CUYAMA BASIN GROUNDWATER SUSTAINABILITY AGENCY STANDING ADVISORY COMMITTEE MEETING

OCTOBER 28, 2021

SUBJECT: Review of Memorandum in Response to DWR's GSP Consultation Letter Dated June 3, 2021

RE: **Cuyama Basin GSA Response to DWR's June 3, 2021, Consultation Letter**

Figure 4-2. Average Well Measurements of Arsenic from 2010 through 2020

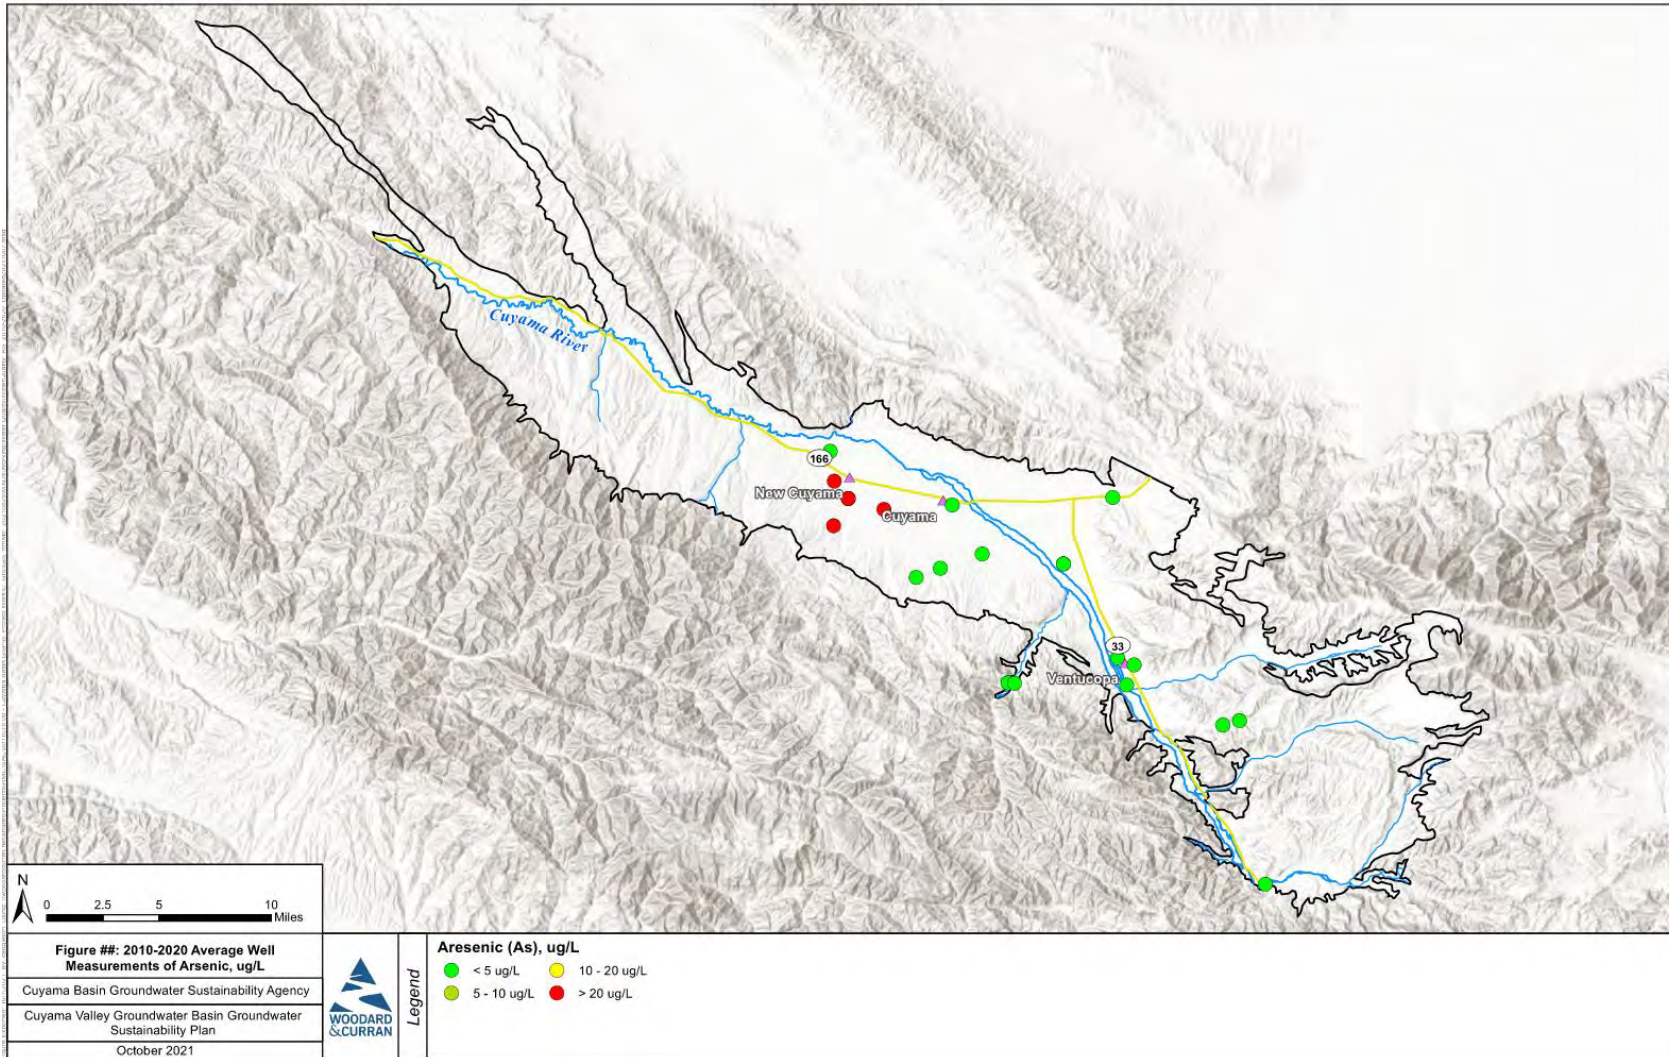
DWR's Letter expressed two main concerns about the water quality analysis and constituent thresholds used in the GSP. First, the GSP acknowledges that nitrate and arsenic have been historical constituents of concern, but due to regulatory limitations, did not set thresholds for these two constituents. Second, based on feedback provided in a public comment, there was concern that some public data was not included in the water quality analysis conducted for the Basin. DWR believes that the GSA may have approached the management strategies differently (through setting thresholds for these constituents) if this data had been utilized. DWR recommended the following to address the concerns raised in the letter:

- Groundwater conditions information related to water quality should be updated to include all available data, in particular as recommended by the Regional Water Quality Control Board, so as to reflect the best available information regarding water quality.
- The GSA should either develop sustainable management criteria for arsenic and nitrate or provide a thorough, evidence-based description for why groundwater management is unlikely to cause significant and unreasonable degradation of groundwater.
- The GSA should appropriately revise its monitoring network based on the above updates. At a minimum, the GSA should include monitoring for arsenic and nitrates as they have been identified as constituents of concern in the basin.

Similarly, because arsenic is naturally occurring, the CBGSA does not believe the establishment of thresholds for arsenic is appropriate. As shown in Figure 4-2, wells with high arsenic concentrations are located in a relatively small area of the basin south of New Cuyama. A review of production well data provided by the counties (discussed in Section 2) indicates that there are no active private domestic wells located in this part of the basin. The only operational public well that is located in this part of the basin serves the Cuyama Community Services District (CCSD). As noted above, the CCSD is currently pursuing the drilling of a new production well, which was included as a project in the GSP. Once this well is completed, it is not believed that any domestic water users will be using a well that accesses groundwater with known high arsenic concentrations.
